UPGRADE OUTLET FILTRATION FOR UNIDOX (INSERTION SECOND FILTER IN PARALLEL)

Actual Configuration (One filter in the outlet)

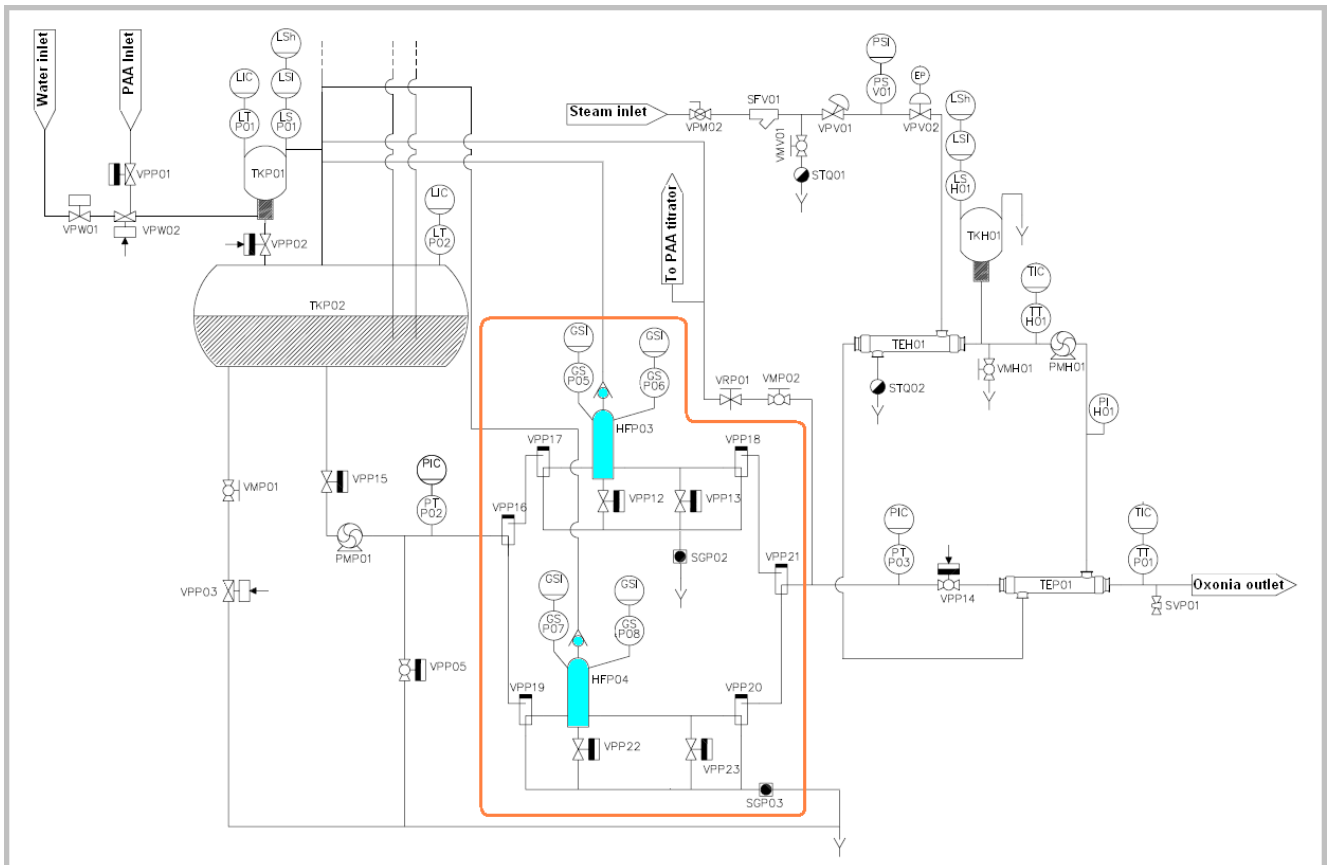
The new filtration group in the outlet will be installed in parallel with the one presently installed, by thus allowing the **production to continue** when the first filter will be jammed. Through the differential pressure control, when the value of the prefixed set value will be reached (it can be set from the operating panel) the filter exchange from the “filter working” to the “filter waiting” will happen automatically without interrupting the oxonia feeding to the plant.
